CITY OF COCONUT CREEK

DEVELOPMENT REVIEW COMMITTEE (DRC) REVIEW #1 – SEPTEMBER 7, 2022

PROJECT NAME:	Gunther Mitsubishi		
PROJECT NUMBER:	PZ-22080004		
LOCATION:	4300-4350 N State Road 7		
APPLICANT/AGENT:	Stiles Architecture		
REVIEW/APPLICATION:	PMDD Site Plan		
DISCIPLINE	REVIEWER	EMAIL	TELEPHONE
DRC Chair Urban Design & Development	Liz Aguiar - Principal Planner	laguiar@coconutcreek.net	(954) 973-6756
Urban Design, Photometrics & Sustainability	Linda Whitman - Senior Planner	lwhitman@coconutcreek.net	(954) 973-6756
Urban Design & Signage	Natacha Josiah - Planner	njosiah@coconutcreek.net	(954) 973-6756
Transportation	Michael Righetti - Senior Project Manager	mrighetti@coconutcreek.net	(954) 973-6756
Building	Sean Flanagan - Deputy Building Official	sflanagan@coconutcreek.net	(954) 973-6750
Engineering	Eileen Cabrera - Senior Engineer	ecabrera@coconutcreek.net	(954) 973-6786
Fire	Ryan Banyas - Fire Marshal	rbanyas@coconutcreek.net	(954) 956-1563
Landscape	Scott Peavler - Landscape (consultant)	speavler@craventhompson.com	(954) 739-6400

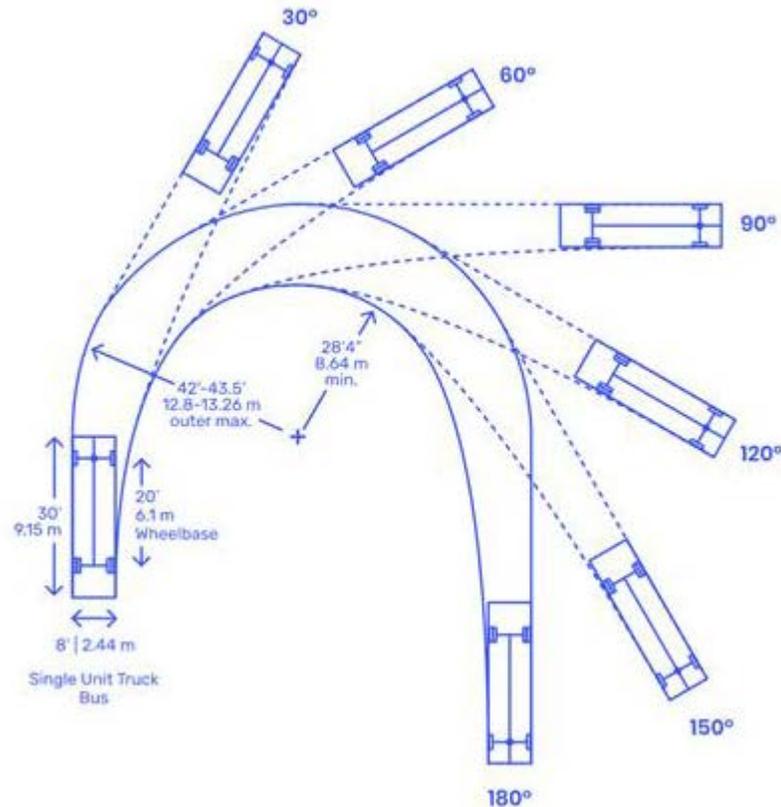
1. The Fire Truck Route Plan shall show turning radius dimensions.
2. A vehicle's turning circle is the radius (or diameter) measured by the outer wheels of the vehicle while making a complete turn, without any physical conflicts (i.e. curbs, light poles, fire hydrants, etc.);
3. A minimum inner turning radius of 28'4" | 8.64 m should be provided for a bus or single-unit truck making a 180° turn.
4. The turning path of a City Fire Truck measures the minimum possible turning radius necessary for performing a *U-turn* in a vehicle with a 20' (6.1 m) wheelbase.
5. Measuring the inner and outer radii of the 180° turn, a minimum inner radius of 28'4" (8.64 m) and minimum outer radius between 42'-43.5' (12.8-13.26 m) should be provided for City Fire Trucks;

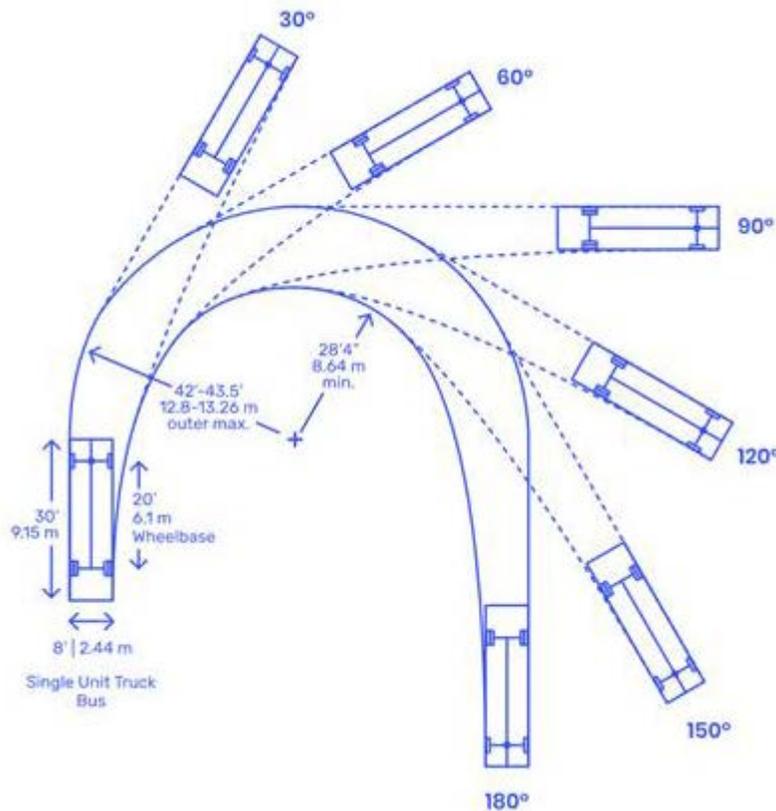
The Fire Truck Route Plan shall show turning radius dimensions.

A vehicle's turning circle is the radius (or diameter) measured by the outer wheels of the vehicle while making a complete turn, without any physical conflicts (i.e. curbs, light poles, fire hydrants, etc.);

A minimum inner turning radius of 28'4" | 8.64 m should be provided for a bus or single-unit truck making a 180° turn.

2. The turning path of a City Fire Truck measures the minimum possible turning radius necessary for performing a *U-turn* in a vehicle with a 20' (6.1 m) wheelbase.
3. Measuring the inner and outer radii of the 180° turn, a minimum inner radius of 28'4" (8.64 m) and minimum outer radius between 42'-43.5' (12.8-13.26 m) should be provided for City Fire Trucks;

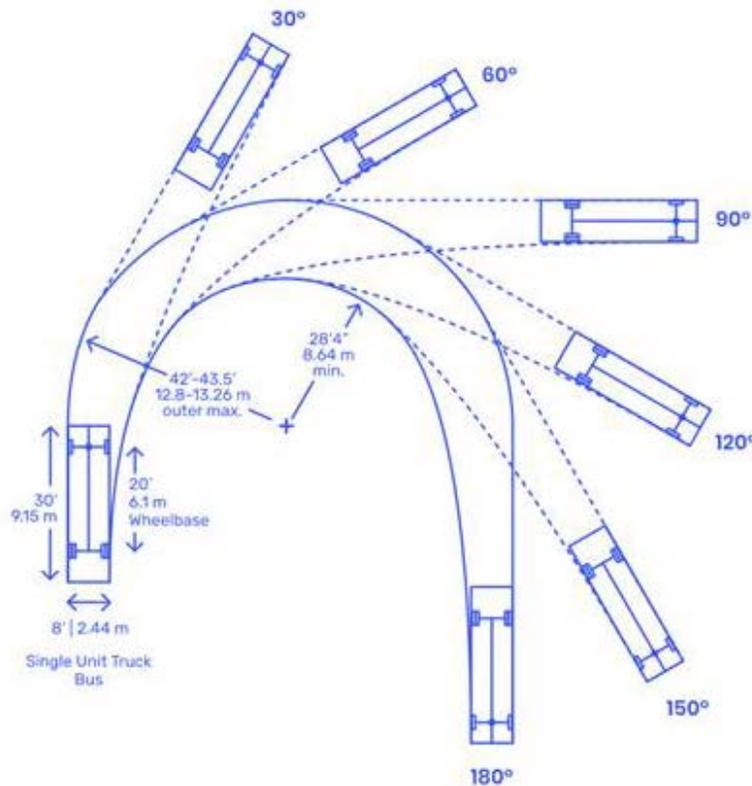
A minimum inner turning radius of 28'4" | 8.64 m should be provided for a bus or single-unit truck making a 180° turn.

The turning path of a City Fire Truck measures the minimum possible turning radius necessary for performing a U-turn in a vehicle with a 20' wheelbase; (6.1 m) wheelbase.

Measuring the inner and outer radii of the 180° turn, a minimum inner radius of 28'4" (8.64 m) and minimum outer radius between 42'-43.5; (12.8-13.26 m) should be provided for City Fire Trucks;
